**MODIFICATION 01 - JUNE 2020**  
**SCHEDULE OF CHANGES**

32 The Strand Whale Beach				
SUMMARY OF BASIX COMMITMENTS				
This is a summary of the BASIX Commitments as detailed in the BASIX Certificate. Refer to the CURRENT BASIX Certificate for Complete details. For definitions refer to basix.nsw.gov.au				
WATER COMMITMENTS				
Fixtures				
3 Star Shower Heads		Yes ( > 4.5 but <= 6 L/min)		
5 Star Kitchen / Basin Taps		Yes	4 Star Toilet	Yes
Alternative Water				
Minimum Tank Size (L)		3000	Collected from Roof Area (m2)	70
Tank Connected To:				
All Toilets		Yes	Laundry W/M Cold Tap	Yes
One Outdoor Tap		Yes		
THERMAL COMFORT COMMITMENTS - Refer to TPA Specification on plans				
ENERGY COMMITMENTS				
Hot Water		Solar (Electric Boost) 21 to 25 STCs		
Cooling System	Living	1 Phase A/C Zoned		EER 2.5 - 3.0
	Bedrooms	1 Phase A/C Zoned		EER 2.5 - 3.0
Heating System	Living	1 Phase A/C Zoned		EER 2.5 - 3.0
	Bedrooms	1 Phase A/C Zoned		EER 2.5 - 3.0
Ventilation	1 x Bathroom	Fan ducted to exterior		Manual on/off

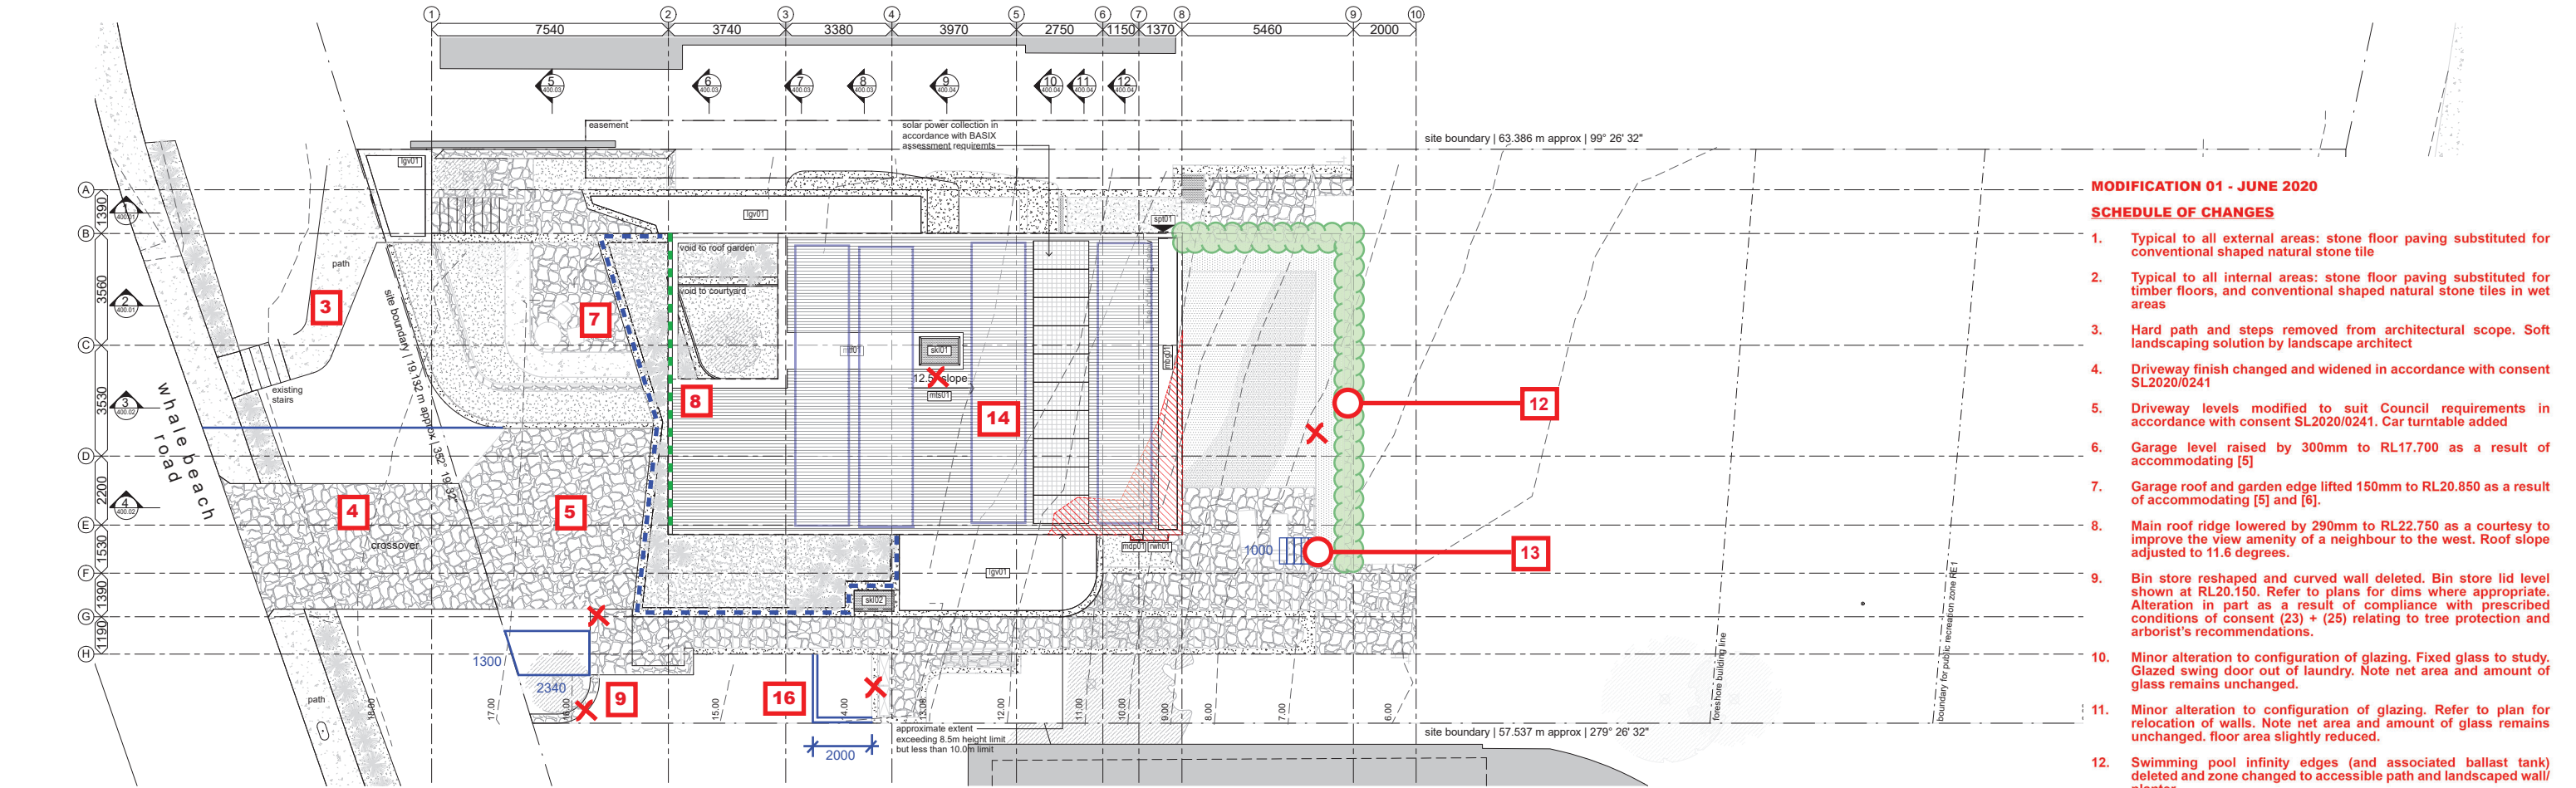
- Typical to all external areas: stone floor paving substituted for conventional shaped natural stone tile
- Typical to all internal areas: stone floor paving substituted for timber floors, and conventional shaped natural stone tiles in wet areas

- Hard path and steps removed from architectural scope. Soft landscaping solution by landscape architect
- Driveway finish changed and widened in accordance with consent SL2020/0241

- Driveway levels modified to suit Council requirements in accordance with consent SL2020/0241. Car turntable added
- Garage level raised by 300mm to RL17.700 as a result of accommodating [5]

- Garage roof and garden edge lifted 150mm to RL20.850 as a result of accommodating [5] and [6].
- Main roof ridge lowered by 290mm to RL22.750 as a courtesy to improve the view amenity of a neighbour to the west. Roof slope adjusted to 11.6 degrees.

- Bin store reshaped and curved wall deleted. Bin store lid level shown at RL20.150. Refer to plans for dims where appropriate. Alteration in part as a result of compliance with prescribed conditions of consent (23) + (25) relating to tree protection and arborist's recommendations.

- Minor alteration to configuration of glazing. Fixed glass to study. Glazed swing door out of laundry. Note net area and amount of glass remains unchanged.

- Minor alteration to configuration of glazing. Refer to plan for relocation of walls. Note net area and amount of glass remains unchanged. floor area slightly reduced.

- Swimming pool infinity edges (and associated ballast tank) deleted and zone changed to accessible path and landscaped wall/planter
- Steps introduced to pool terrace to access service path. Refer to plans for dims where appropriate.

- Extra solar panels added to increase energy efficiency of development
- Block wall moved down to align with pool equipment adjacent as shown. Note this change is underground and not visible to the public or neighbours.

- Plant and equipment store area increased by moving western wall further west in order to accommodate the required equipment with ventilation and service space. Refer to plans for dims where appropriate.

- Block wall to be changed to screening for ventilation and sound attenuation
- Seat added
- Landscape plan amended in accordance with prescribed conditions of consent (15) + (38).

- Height of landscaped wall facing street to be increased to the North to a max height of 1800mm above ground level to follow natural topography.

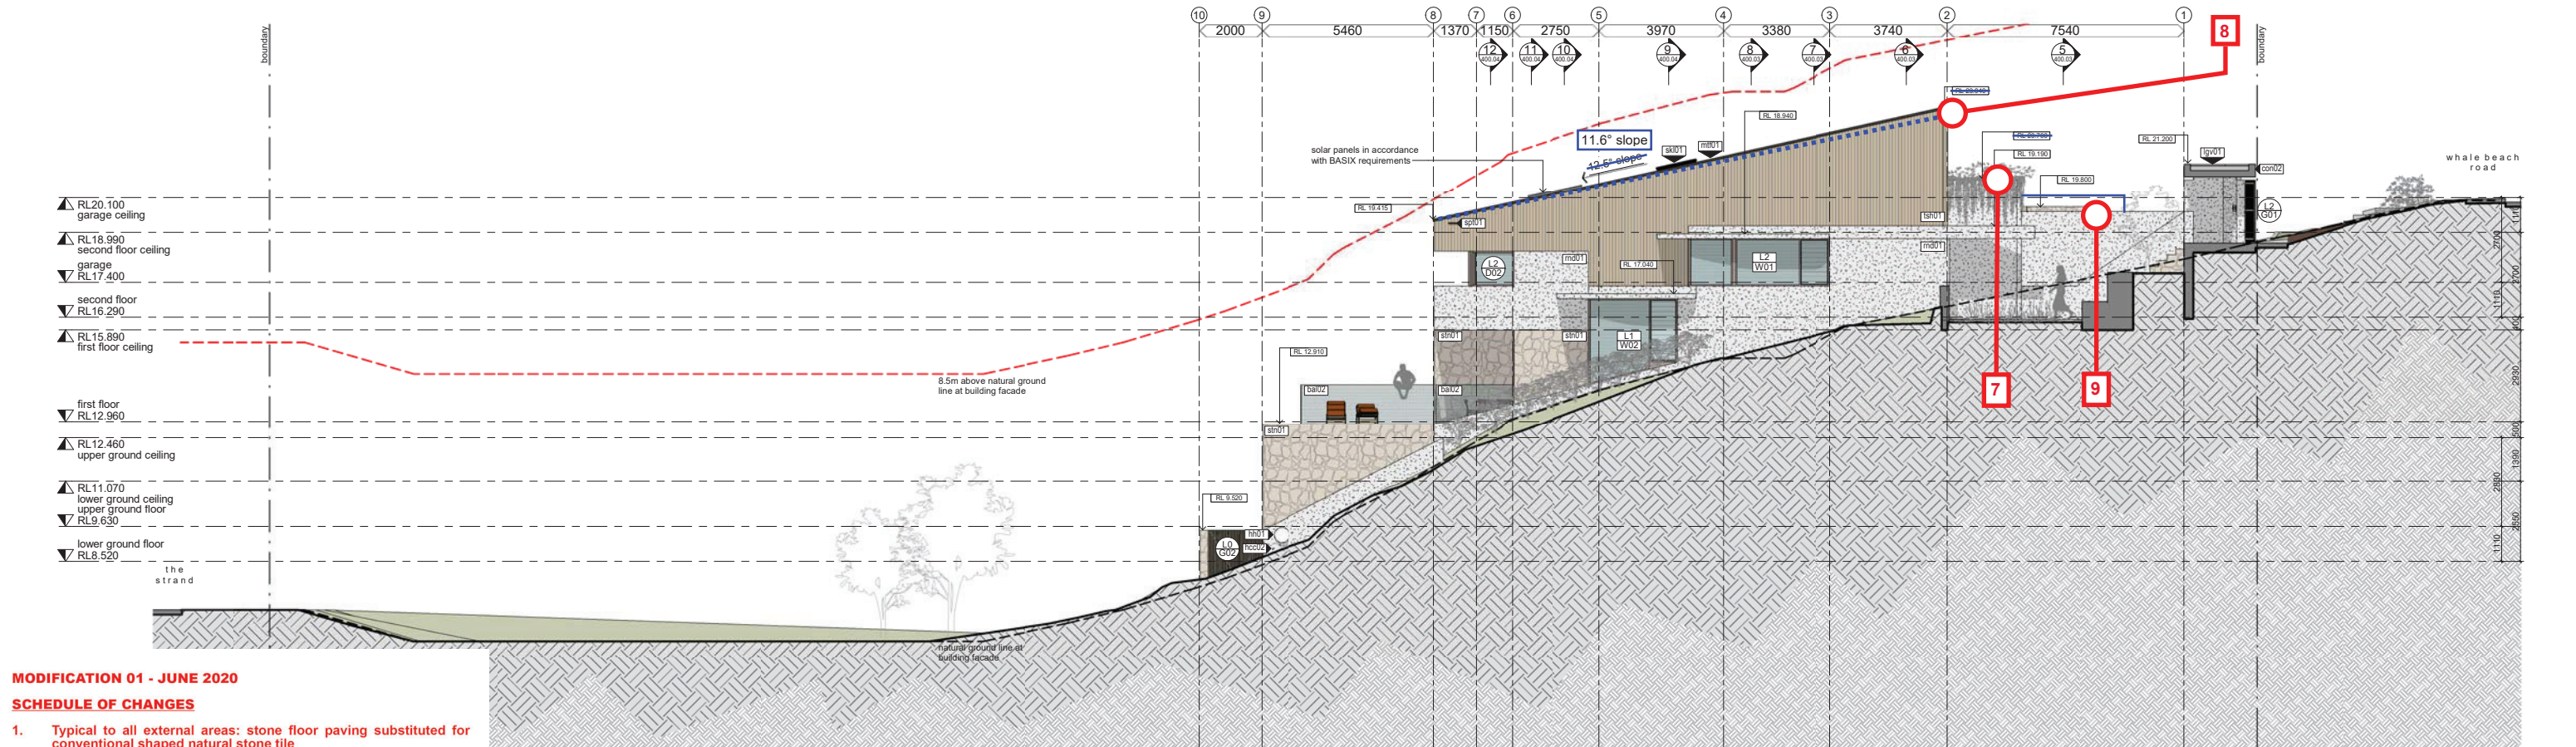
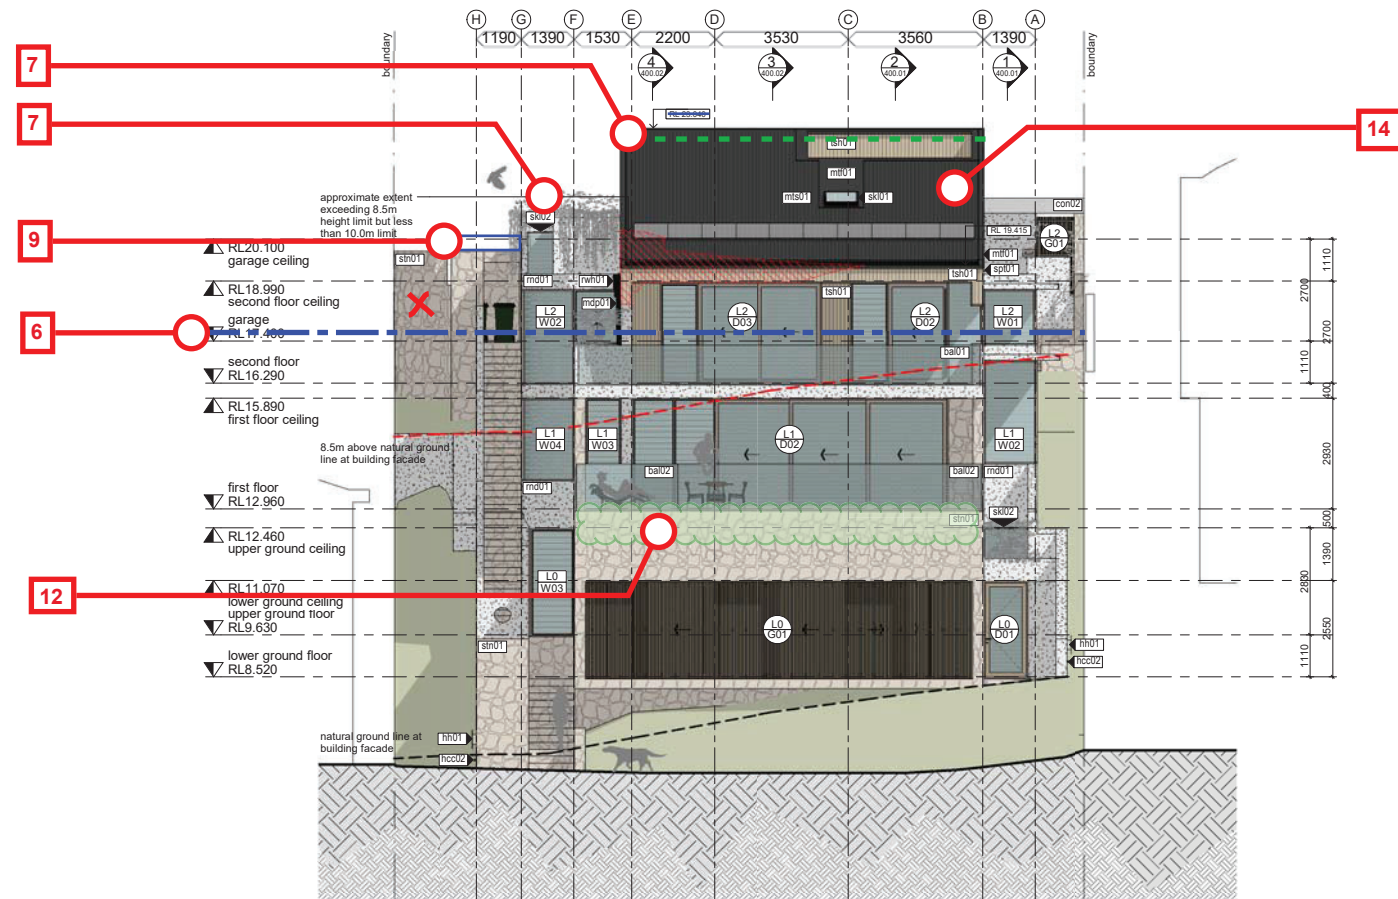
- Typical to all external areas: stone floor paving substituted for conventional shaped natural stone tile
- Typical to all internal areas: stone floor paving substituted for timber floors, and conventional shaped natural stone tiles in wet areas

- Hard path and steps removed from architectural scope. Soft landscaping solution by landscape architect
- Driveway finish changed and widened in accordance with consent SL2020/0241

- Driveway levels modified to suit Council requirements in accordance with consent SL2020/0241. Car turntable added
- Garage level raised by 300mm to RL17.700 as a result of accommodating [5]

- Garage roof and garden edge lifted 150mm to RL20.850 as a result of accommodating [5] and [6].
- Main roof ridge lowered by 290mm to RL22.750 as a courtesy to improve the view amenity of a neighbour to the west. Roof slope adjusted to 11.6 degrees.

- Bin store reshaped and curved wall deleted. Bin store lid level shown at RL20.150. Refer to plans for dims where appropriate. Alteration in part as a result of compliance with prescribed conditions of consent (23) + (25) relating to tree protection and arborist's recommendations.

- Minor alteration to configuration of glazing. Fixed glass to study. Glazed swing door out of laundry. Note net area and amount of glass remains unchanged.

- Minor alteration to configuration of glazing. Refer to plan for relocation of walls. Note net area and amount of glass remains unchanged. floor area slightly reduced.

- Swimming pool infinity edges (and associated ballast tank) deleted and zone changed to accessible path and landscaped wall/planter
- Steps introduced to pool terrace to access service path . Refer to plans for dims where appropriate.

- Extra solar panels added to increase energy efficiency of development
- Block wall moved down to align with pool equipment adjacent as shown. Note this change is underground and not visible to the public or neighbours.

- Plant and equipment store area increased by moving western wall further west in order to accommodate the required equipment with ventilation and service space. Refer to plans for dims where appropriate.

- Block wall to be changed to screening for ventilation and sound attenuation
- Seat added
- Landscape plan amended in accordance with prescribed conditions of consent (15) + (38).

- Height of landscaped wall facing street to be increased to the North to a max height of 1800mm above ground level to follow natural topography.
